Dragoni Fashions Ltd.

21st May 2014

Non-structural Observations

Lack of Edge Protection at Roof Level

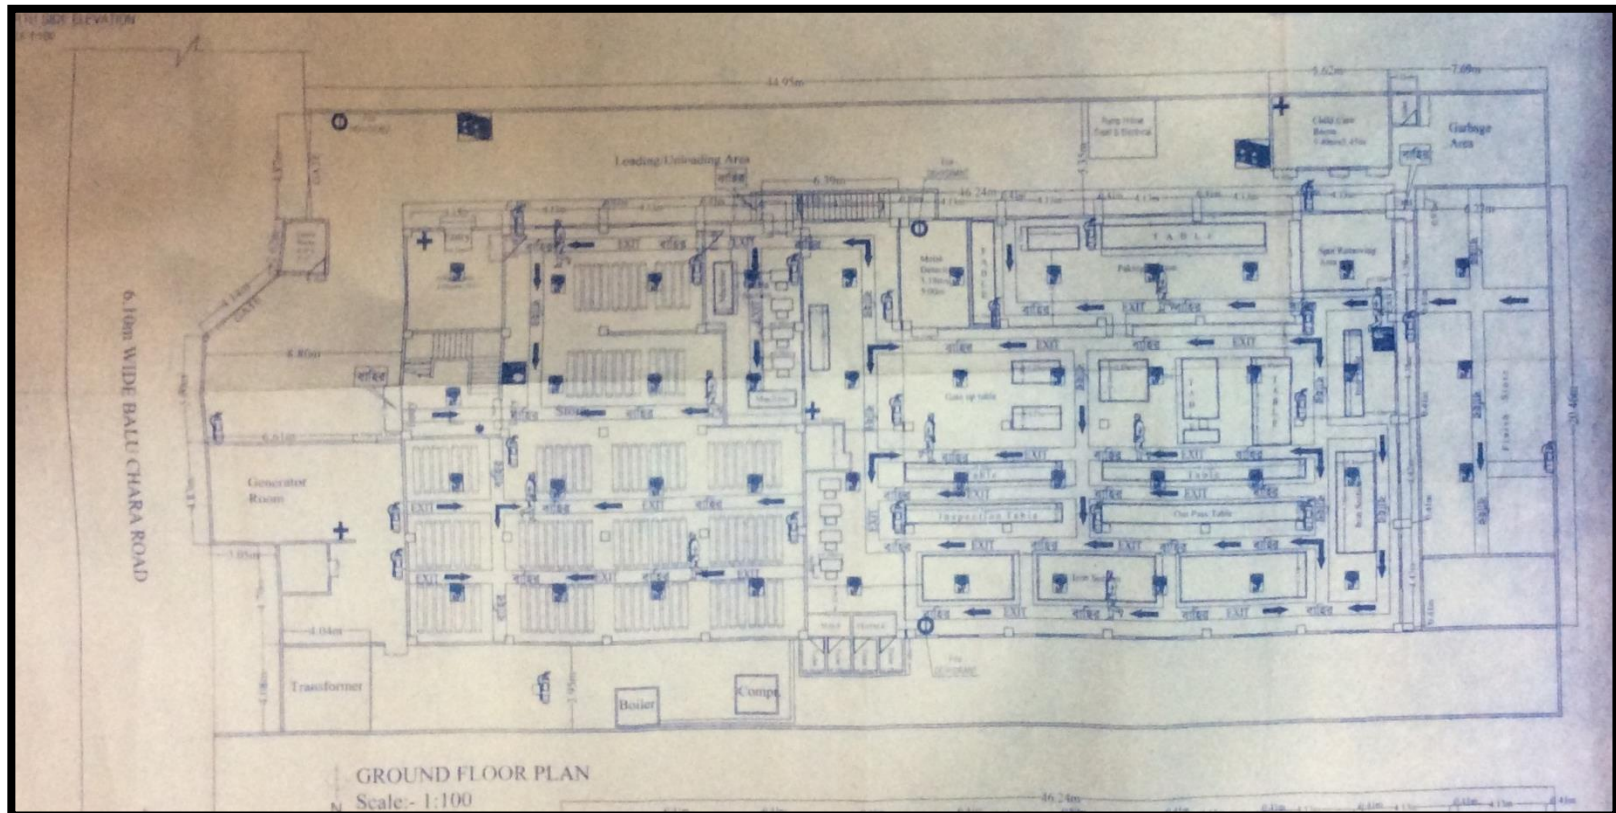
An immediate concern was raised with factory management regarding the lack of edge protection at the balconies on the building.

Lack of edge protection

High loading in toilet areas on cantilevers

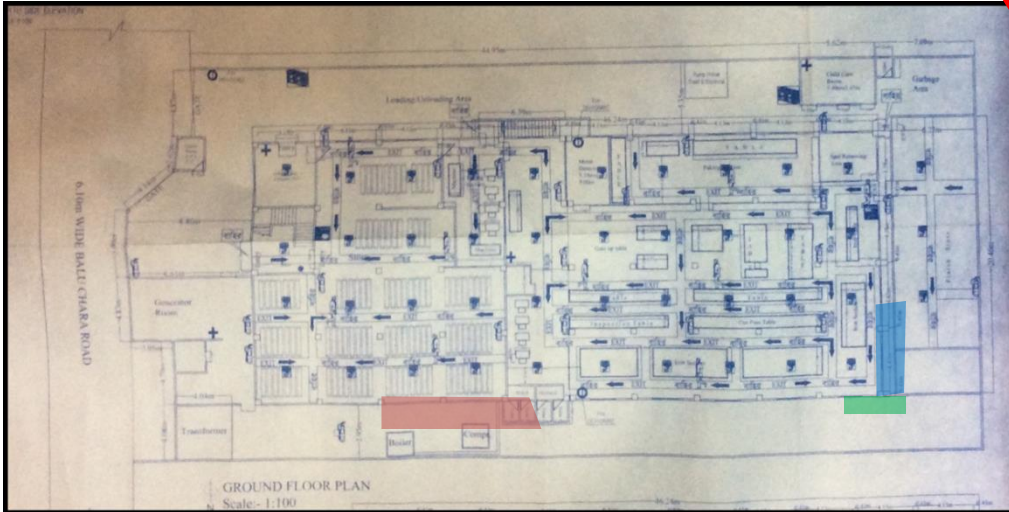
High loading was observed on cantilevers, especially in toilet areas with floor build-up.

Toilets at Levels 1, 2 & 3

Toilets at Levels 1, 2, 3, 4 (toilets are positioned at different locations within this zone at each level)

Toilets at Levels 4 only

9	High loading in toilet areas on cantilevers	Carry out load reduction and/or any remedial work as directed by the Factory Engineer.	6-months

Cracking on floor surface

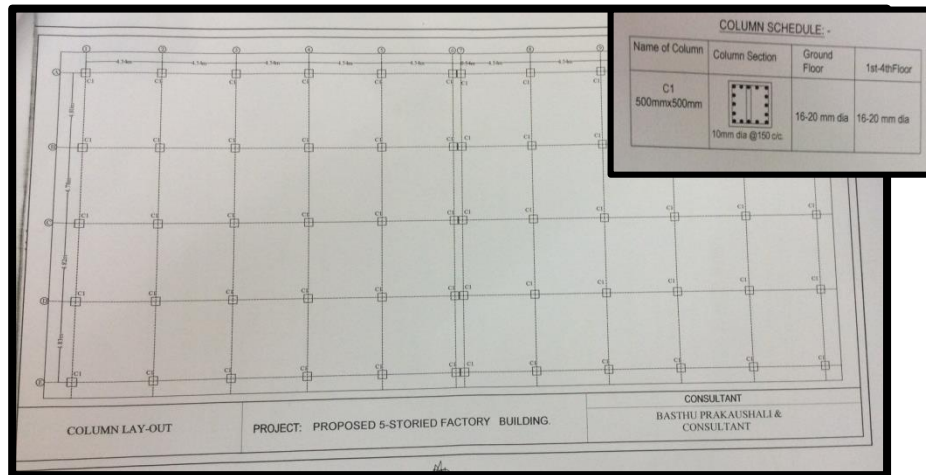
Cracking was observed in the surface of the floor slab finish generally along the lines between columns.

Item No.	Observation	Recommended Action Plan	Recommended Timeline
10	Cracking on floor surface	As part of the Detail Engineering Assessment (see Item 1), Factory Engineer to investigate if the cracking is structural or exists only in the screed finish	6-weeks
11	Cracking on floor surface	Carry out any remedial work as directed by the Factory Engineer.	6-months
12	Discrepancies between site observations and information on drawings	As part of the Detail Engineering Assessment (see Item 1), Factory Engineer to update the engineering drawings.	6-weeks
13	Apparently non-engineered roof structures	Building engineer to check the capacity of the lightweight roofs and make any necessary alterations.	6-months

Column layout drawing

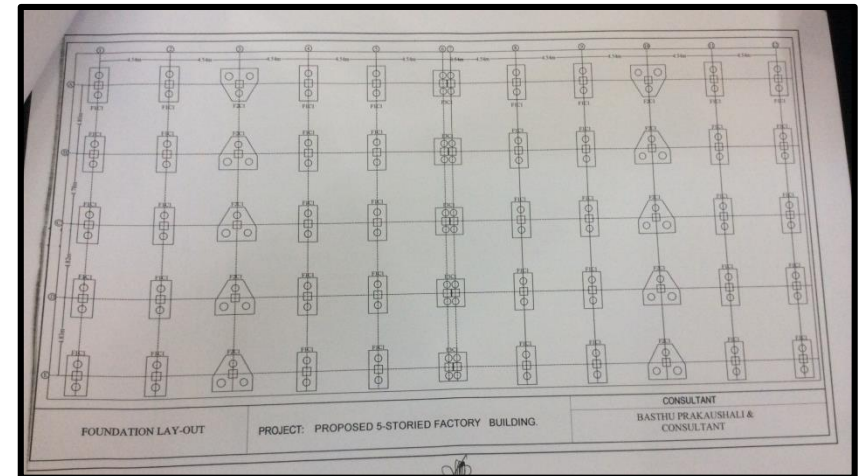
Structural drawings which were provided contradicted several observations made, and architectural drawings were unclear – most notably:-

- The structural drawings showed columns of 500 x 500 across the entire grid; however, 300 x 380 internal columns and 300 x 300 perimeter columns were observed. The number of bars scanned in columns also differed from the drawings.
- Structural drawings neglected to show cantilevers which extended from all four faces of the building.
- Pile layout was provided, whilst the site investigation recommended pad foundations.
- Architectural drawings misrepresented the locations of some toilet areas and stairs.
